**TASMANIA DEPARTMENT OF MINES
UNPUBLISHED REPORT 1979/60**

Examination of a proposed house site at Windermere

Figure 1

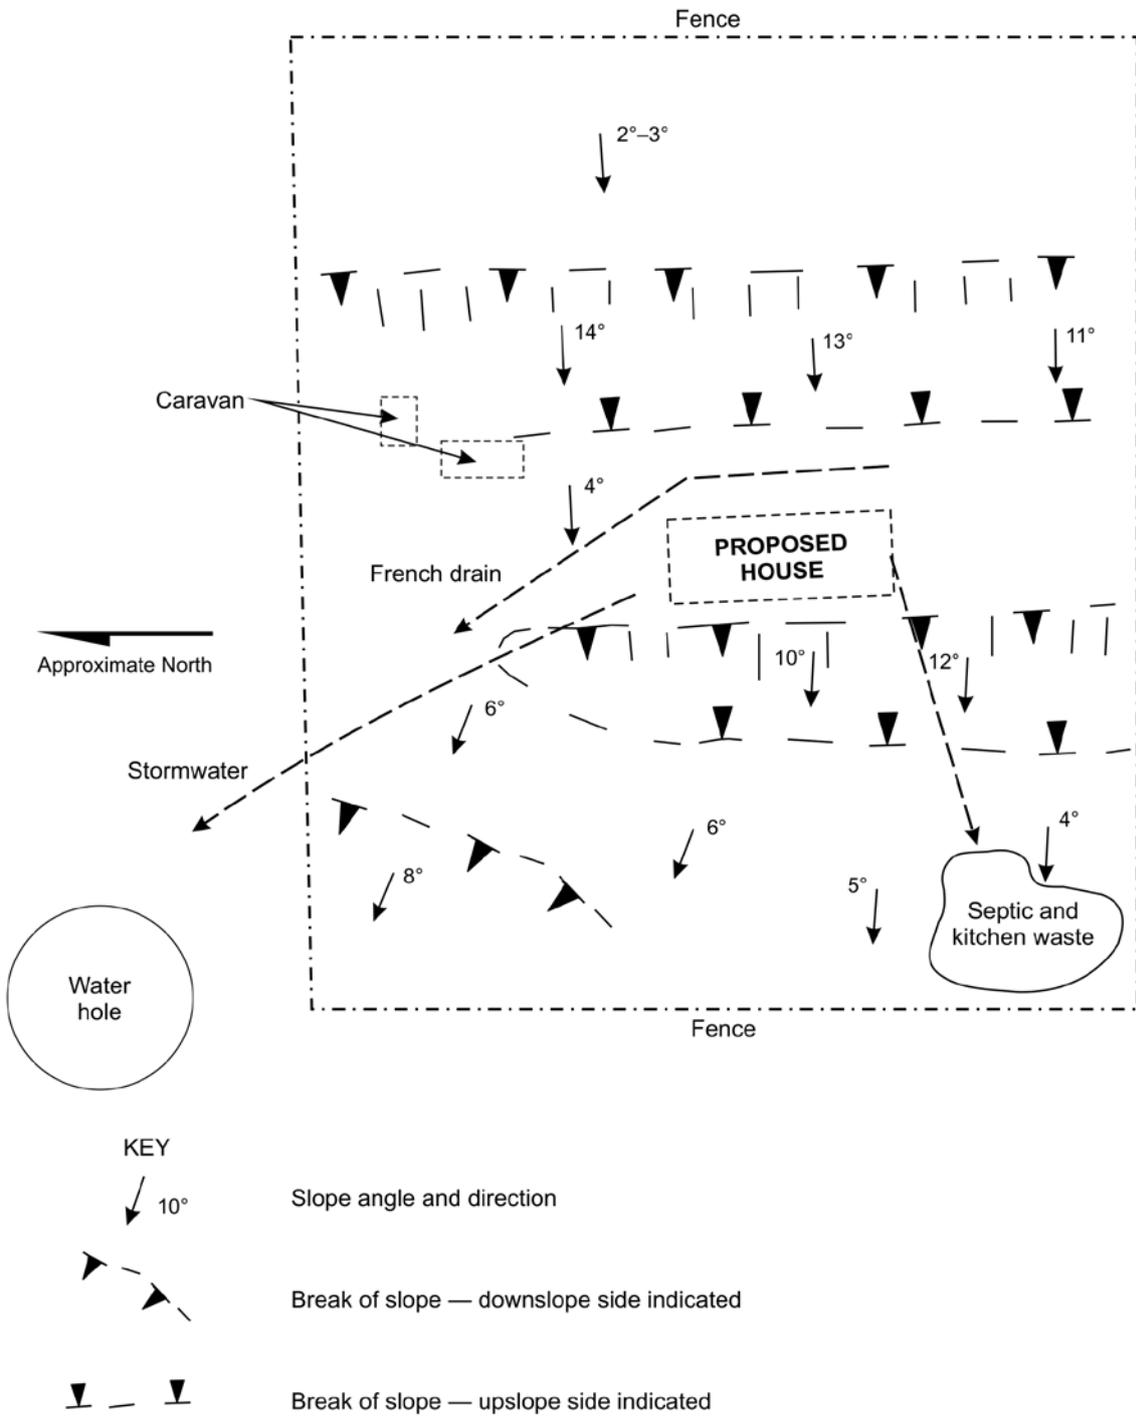
It is advised that the *Building Regulations 1978 Part IV Division 5* be adhered to as far as possible. It is also advised that the house be constructed in the area already outlined on the allotment. A French drain should be constructed at the foot of the slope behind the house to carry any water towards the waterhole. Stormwater should be also directed towards the waterhole. Septic tank effluent should be disposed of to the south of the proposed house on the gently sloping area outlined on Figure 1. This sketch map indicates the morphology of the allotment and indicates the areas outlined above. It should be noted that this area in general contains many features which may be indicative of old landslips. The above precautions are designed to reduce the risk of building in these areas.
